ADA Curb Ramp New Construction Inspection Form (Perpendicular)

NW 311th Ave

24952.54

NW Moon St

PERPENDICULAR RAMP (PR)

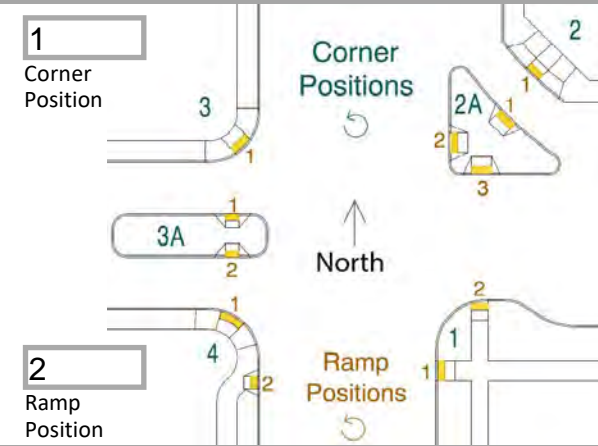
☒

☒

Poor craftsmanship in gutter area
